ADDENDUM NO. 1

RE: Item #1, June 3, 2026 Letting - P TAPU(47), PCN 09QH, Pennington County - Grading, PCC Sidewalk & Culverts

SD DOT	PROJECT	SHEET	TOTAL SHEETS
	P TAPU(47)	28	112

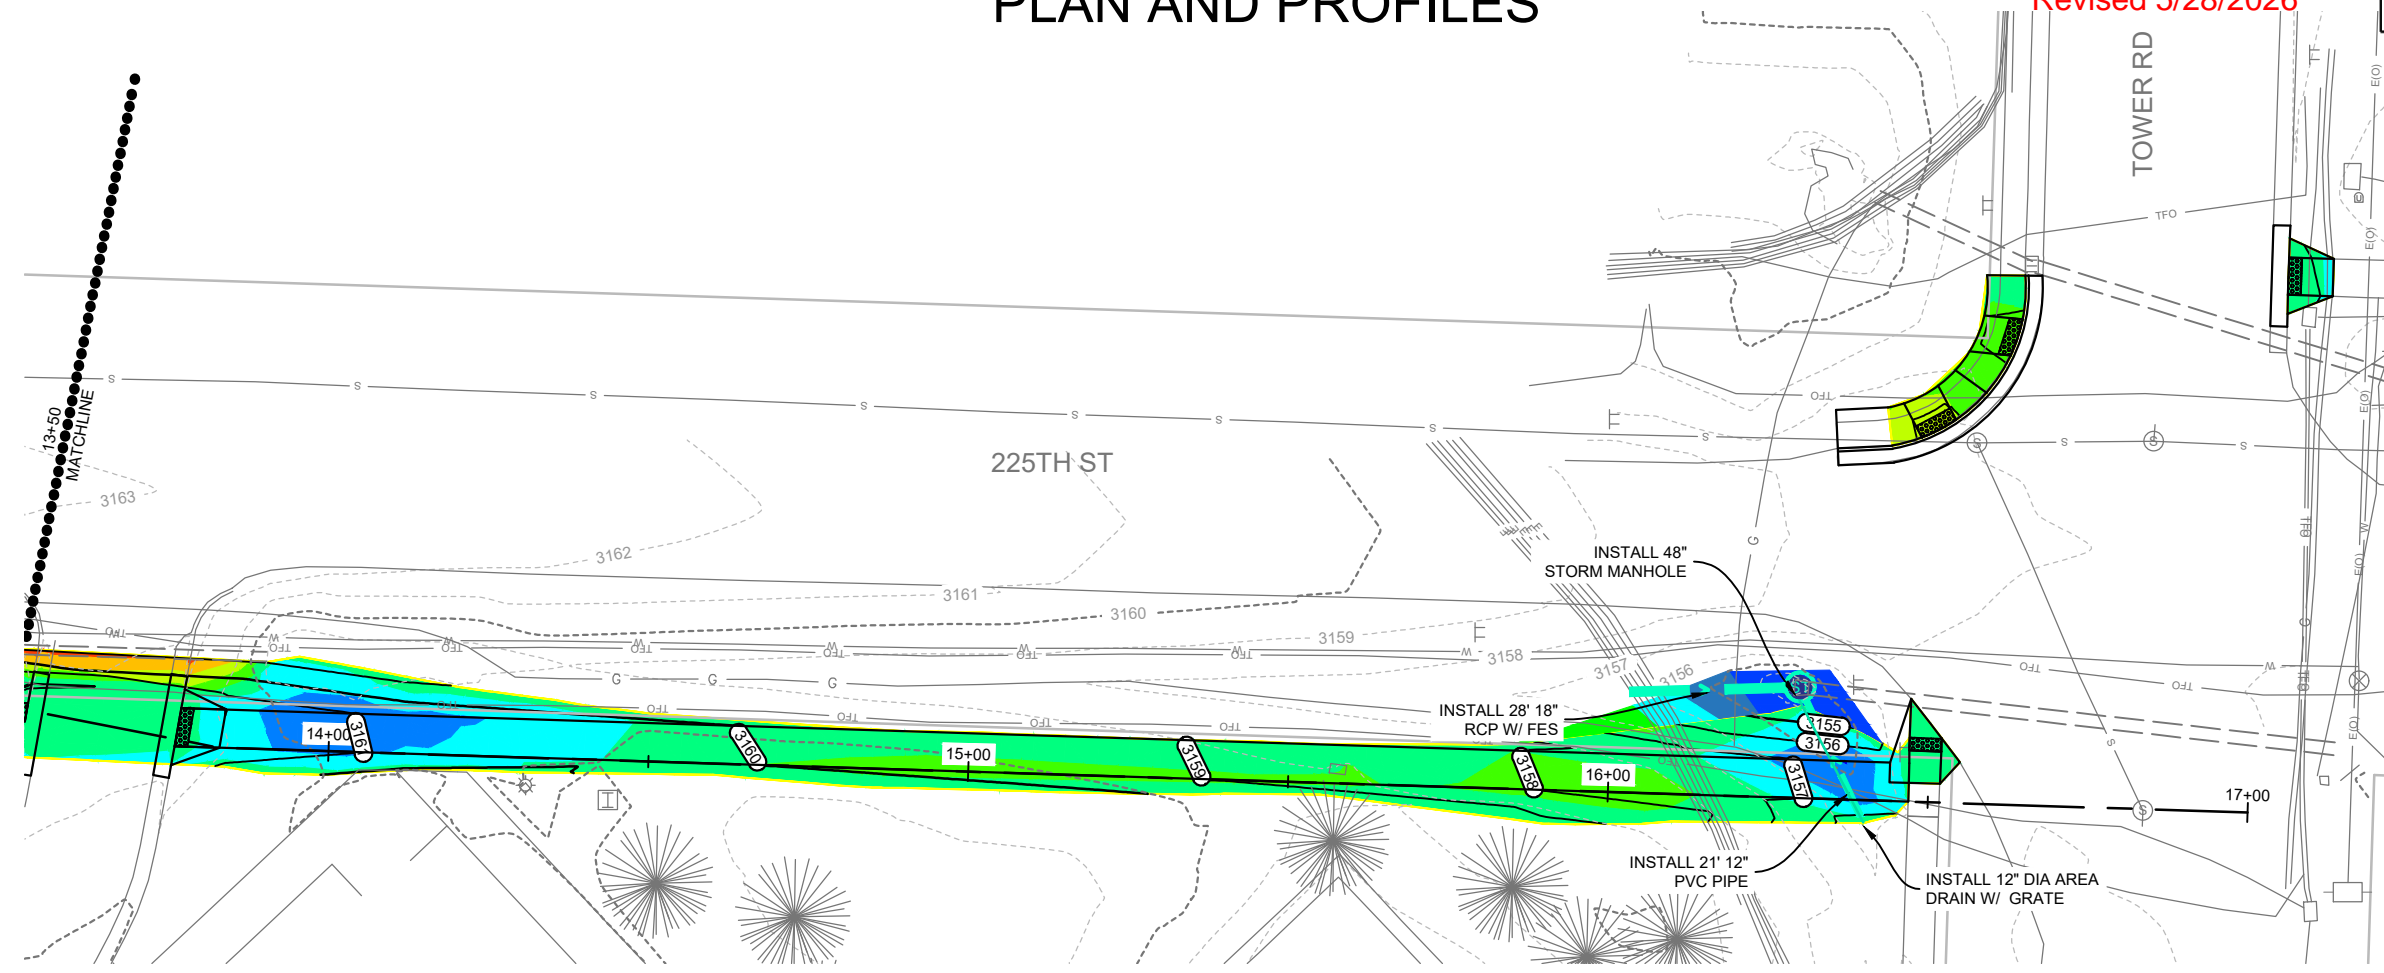
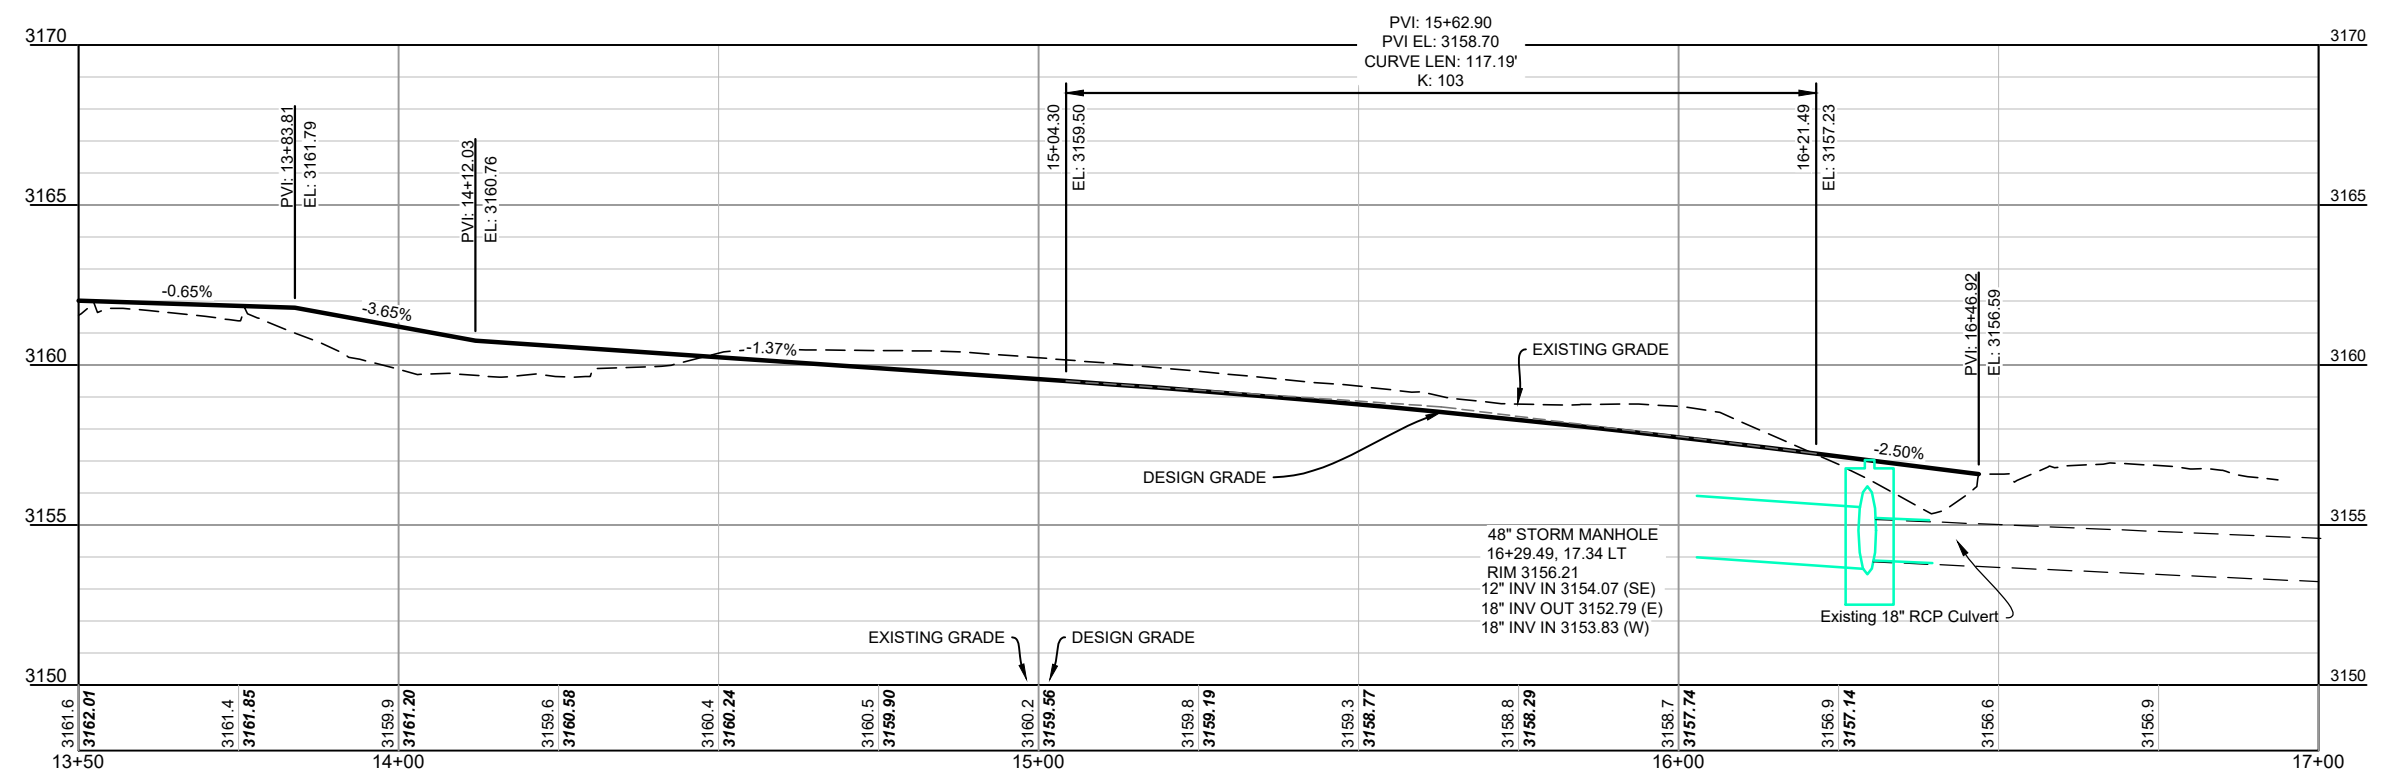
Sheet 28: Area Drain callout was revised.

SD DOT	PROJECT	SHEET	TOTAL SHEETS
	P TAPU(47)	47	112

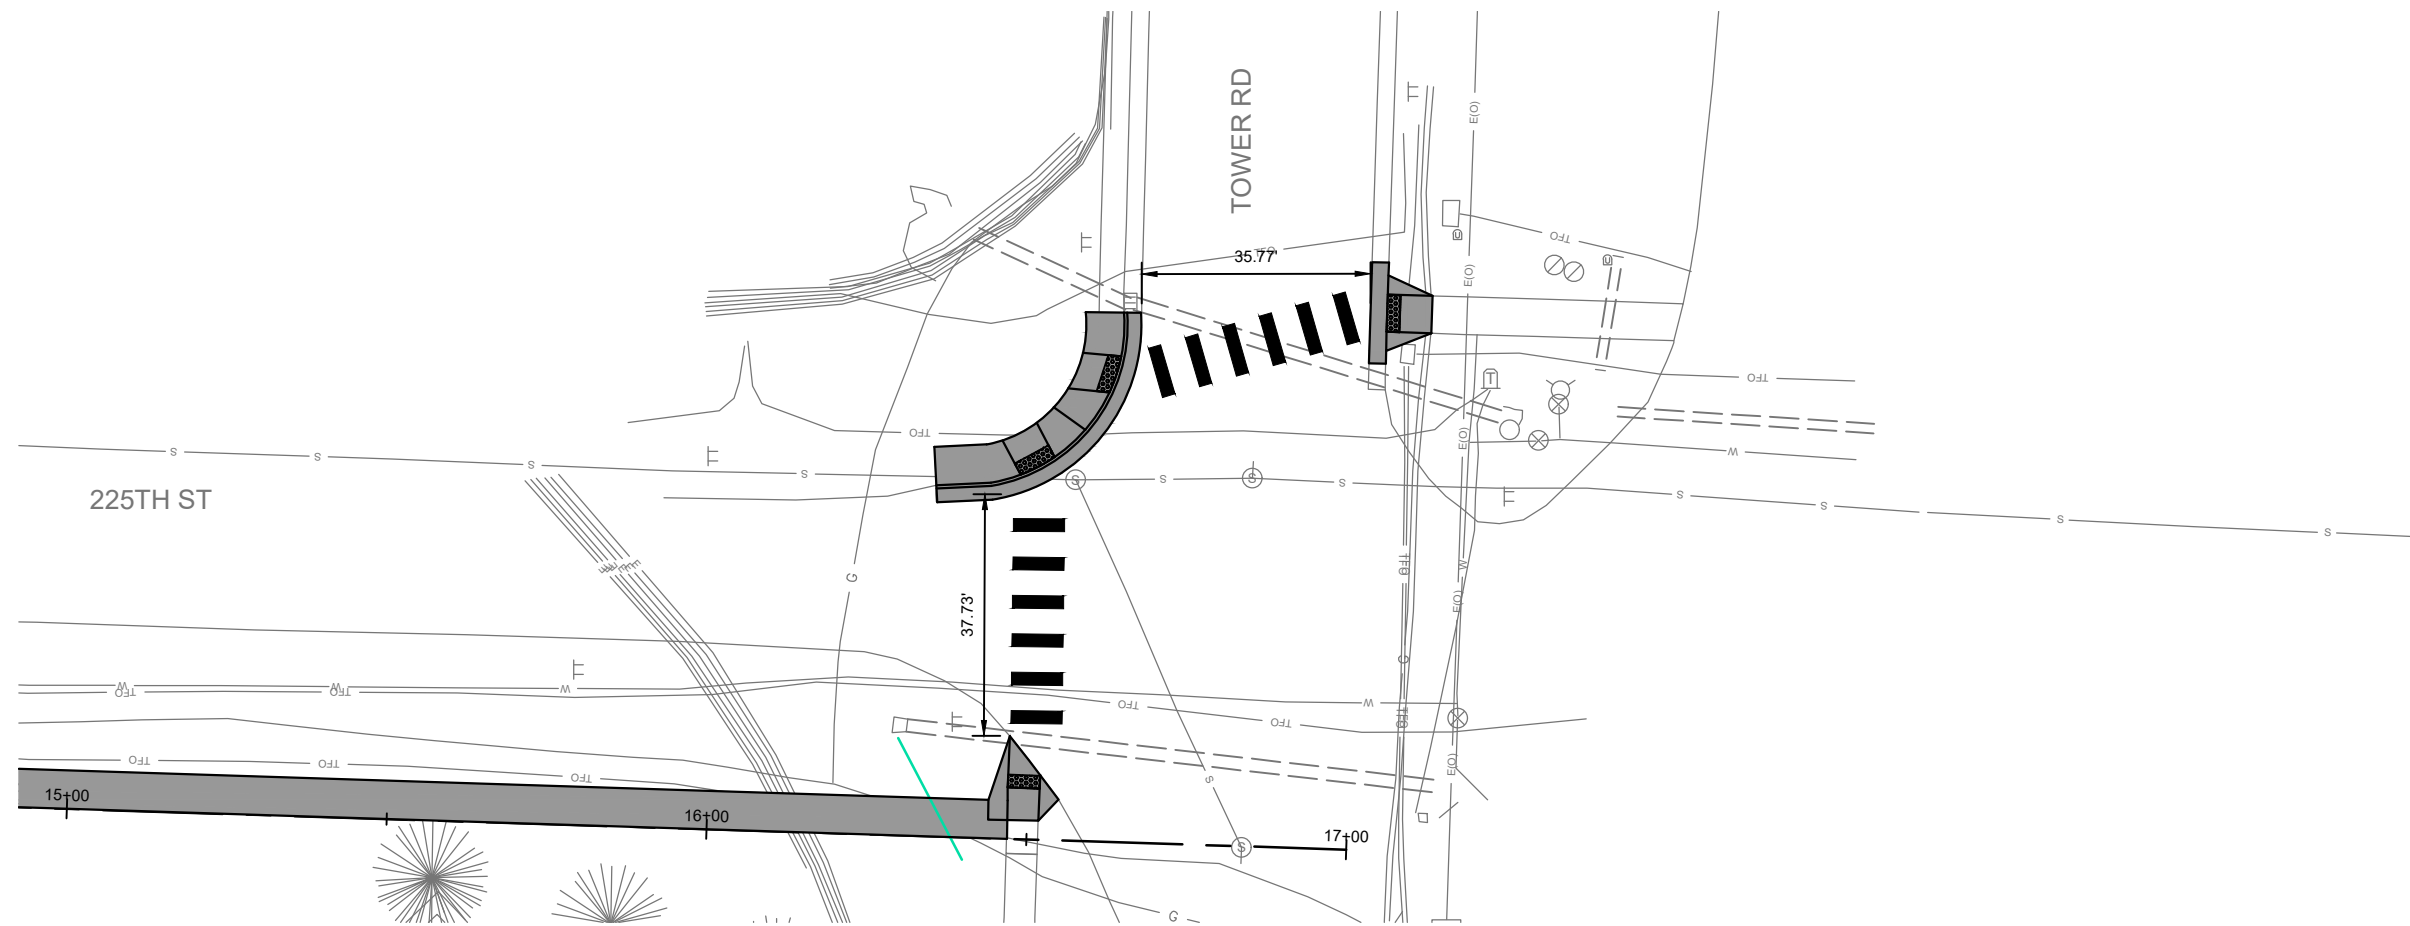
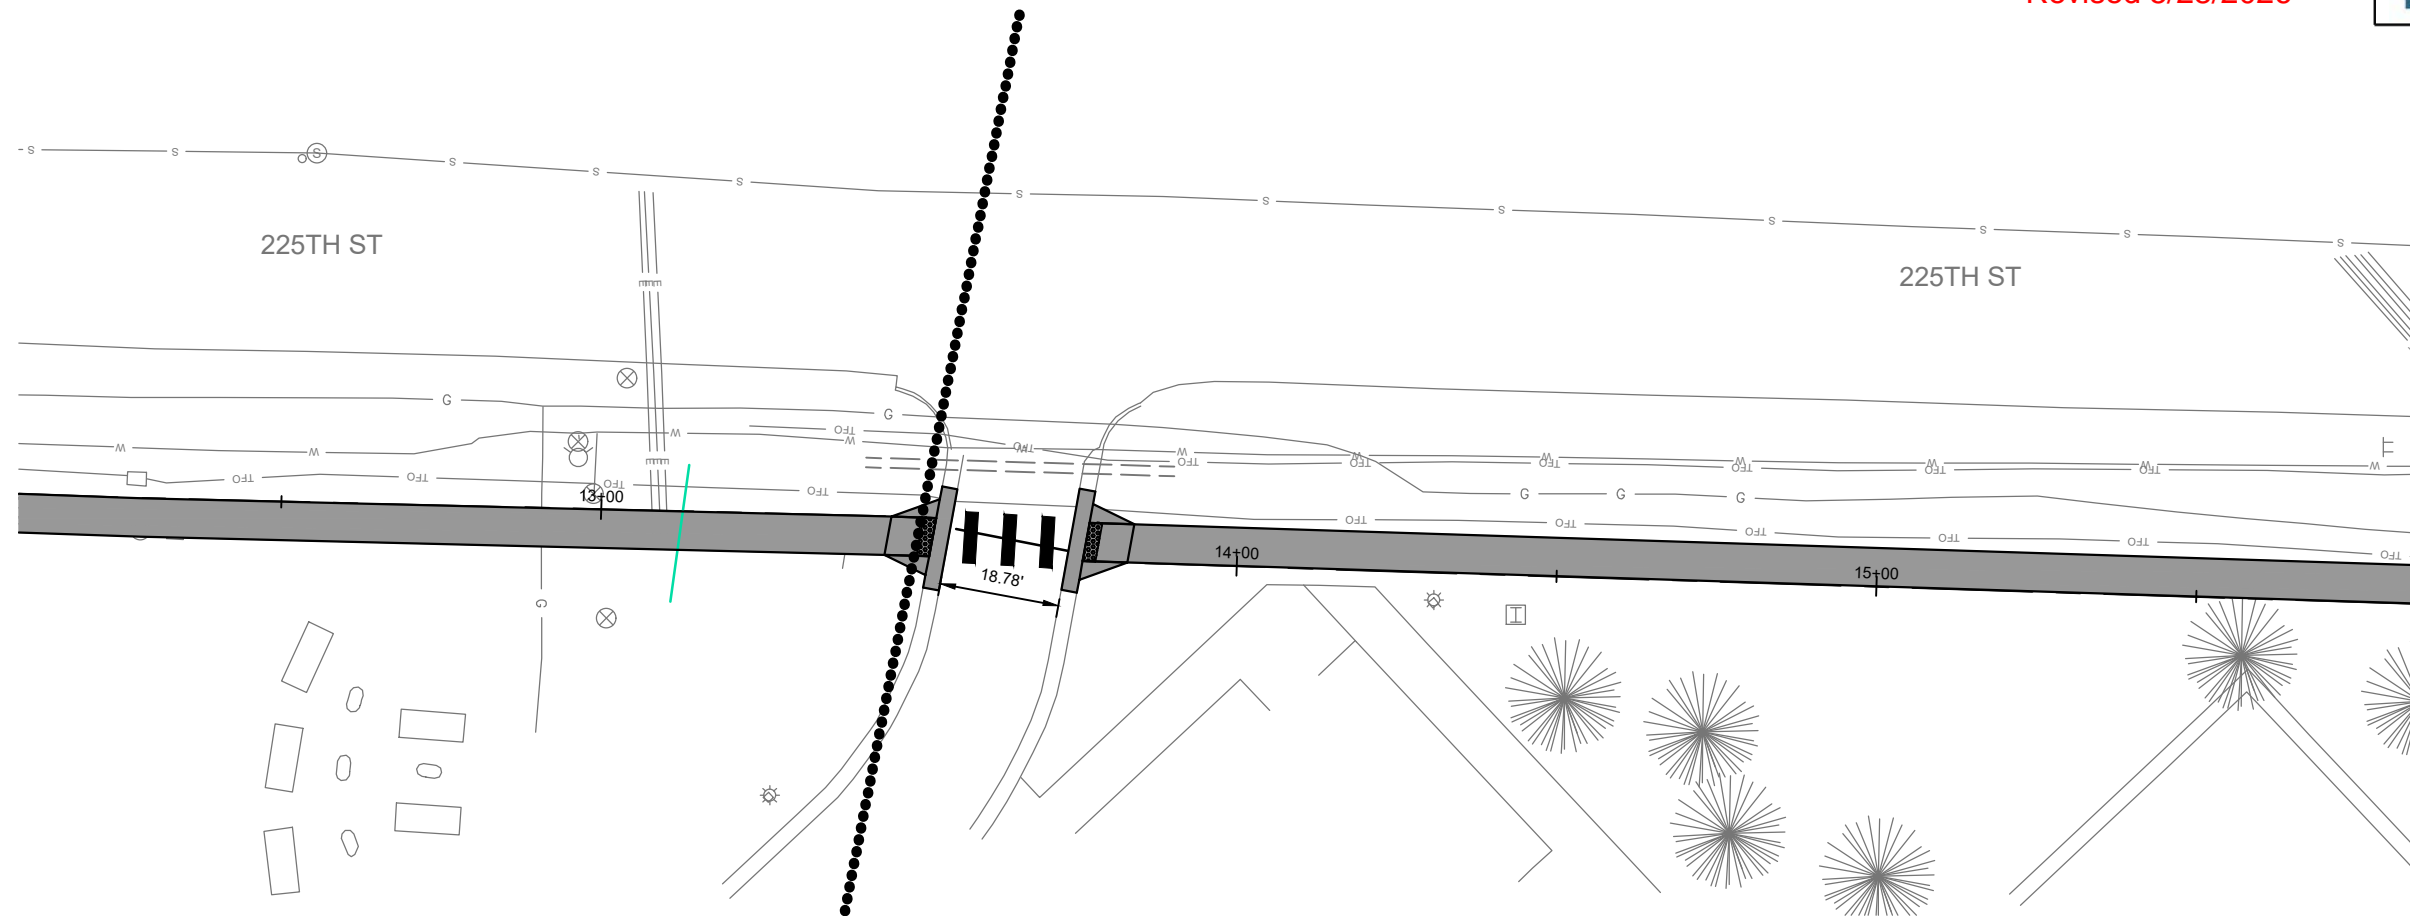
Sheets 47-49: QUANTITIES THIS SHEET notes were revised.

QUANTITIES THIS SHEET
COLD APPLIED PAVEMENT MARKING 73 FT
24" WHITE
